PROJECT TITLE:
DRMO SHORELINE REHABILITATION

Subject: Final Action Memorandum
Site 6, Defense Reutilization and Marketing Office (DRMO) Shoreline Stabilization
Portsmouth Naval Shipyard
Kittery, Maine

**RESPONSES TO USEPA COMMENTS DATED DECEMBER 12, 2000
DRMO SHORELINE STABILIZATION DRAFT REMOVAL ACTION REPORT
PORTSMOUTH NAVAL SHIPYARD, KITTERY, MAINE
SUBMITTED OCTOBER 13, 2000**

**RESPONSES TO MEDEP COMMENTS DATED JANUARY 2, 2001
DRMO SHORELINE STABILIZATION DRAFT REMOVAL ACTION REPORT
PORTSMOUTH NAVAL SHIPYARD, KITTERY, MAINE
SUBMITTED OCTOBER 13, 2000**

**FIGURE 4
DRMO Shoreline Stabilization:
As-Built Cross Section**

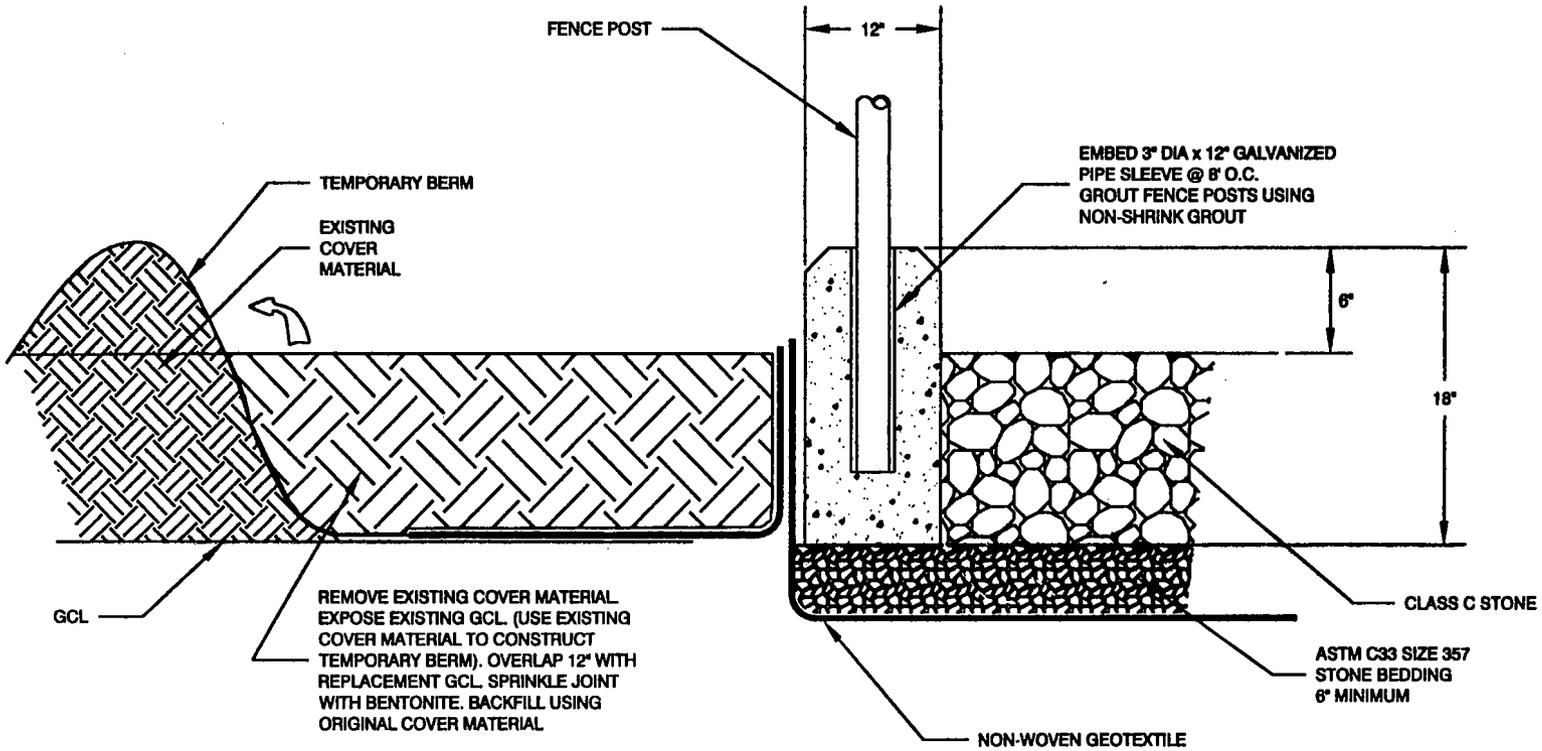
- a) **Comment:** The title box of this figure reads, "Figure 4-1" indicating it is from a different document. This figure should be an as-built figure of the shoreline stabilization. Please clarify that this is or is not the case.

Response: The shoreline cross-section is an as-built figure, and the title block has been revised to indicate this.

| <p>FIGURE 5 DRMO Shoreline Stabilization: As-Built Curb Detail</p> |

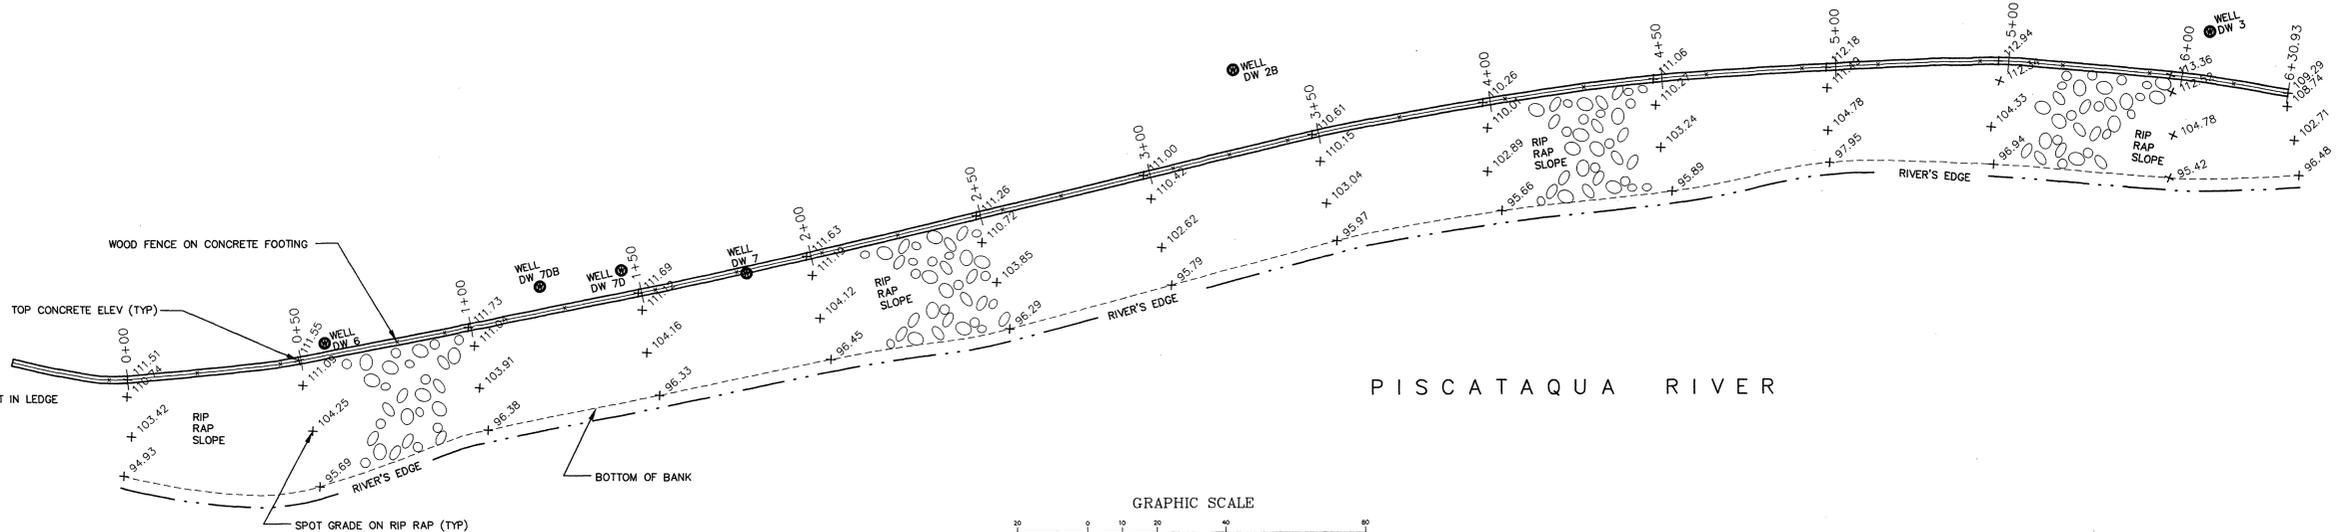
- b) **Comment:** This figure indicates that there should be figure showing curb detail. There is no such figure. Please include a figure showing curb detail.

Response: A figure showing the curb detail has been included as requested.

- a) **Comment:** There is no discussion in the text regarding this figure. There should be.

- b) **Comment:** The title on the fold-out reads "Slope Stabilization". The title page insert reads, "Slope Survey".

- c) **Comment:** On the figure, the Engineer's Seal is not legible. Please correct.

- d) **Comment:** The figure needs a footnote that explains the elevation datum that is used in the profiles.

Response: A reference to Figure 6, Slope Stabilization, has been provided in Section 2.2.2.4.3 Shoreline Stabilization.

Response: The Table of Contents has been corrected to read "Slope Stabilization".

Response: The figure has been corrected to provide a more legible Land Surveyor's Seal. Also, the following note has been added to the figure:

"Jerome B. Watts, PLS #1245".

Response: The following note has been added to the figure:

"Vertical-Horizontal Datums are based on a plan entitled, "Control Map", Scale 1"=200', provided by Engineering Department of Portsmouth Naval Shipyard in Kittery, Maine."
